Service Bulletin

SUBJECT: Service Update for Inventory Vehicles Only
Transmission to Engine Bolt Torque
Expires April 30, 2017

MODELS: 2016 Chevrolet Silverado
2016 GMC Sierra

41710 - Service Update - Transmission to Engine Bolt Torque

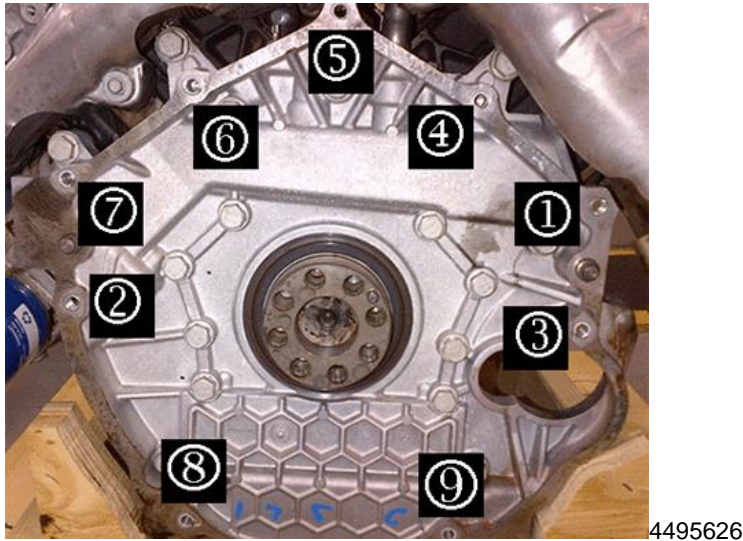
Illustration depicts a diesel engine. The gasoline engine does not have a bolt at position 4.

8. Loosen the transmission bolts in the sequence shown.

Note: Position 4 does not apply to gasoline engine.

9. Tighten the transmission bolts 1 and 2 to 50 Nm (37 lb. ft.). Starting with position 1 again, tighten bolts in sequence 1-9 as shown to 50 Nm (37 lb. ft.).
10. Install the fuel line bracket nut on the back of the transmission at the engine and reposition the fuel line bracket.
11. Raise the transmission back into place.
12. Install the three-way catalytic converter. Refer to *Three-Way Catalytic Converter Replacement* in SI.
13. Install the front axle propeller shaft, if equipped. Refer to *Front Axle Propeller Shaft Replacement* in SI.
14. Install the transmission support crossmember. Refer to *Transmission Support Crossmember Replacement* in SI.
15. Install the rear propeller shaft. Refer to *Rear Propeller Shaft Replacement* in SI.
16. Lower the vehicle. Refer to *Lifting and Jacking the Vehicle* in SI.

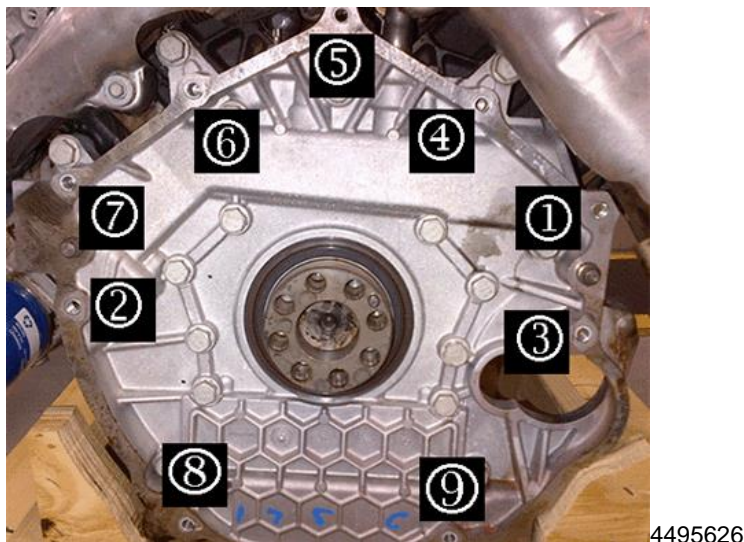
Illustration depicts a diesel engine. The gasoline engine does not have a bolt at position 4.

5. Loosen the transmission bolts in the sequence shown.

Note: Position 4 does not apply to gasoline engine.

- 6. Tighten the transmission bolts 1 and 2 to 50 Nm (37 lb. ft.). Starting with position 1 again, tighten bolts in sequence 1-9 as shown to 50 Nm (37 lb. ft.).
- 7. Reposition the wire harness/vent tube bracket and install the wire harness/vent tube bracket nut.
- 8. Raise the transmission back into place.
- 9. Install the transmission support crossmember. Refer to *Transmission Support Crossmember Replacement* in SI.
- 10. Lower the vehicle. Refer to *Lifting and Jacking the Vehicle* in SI.
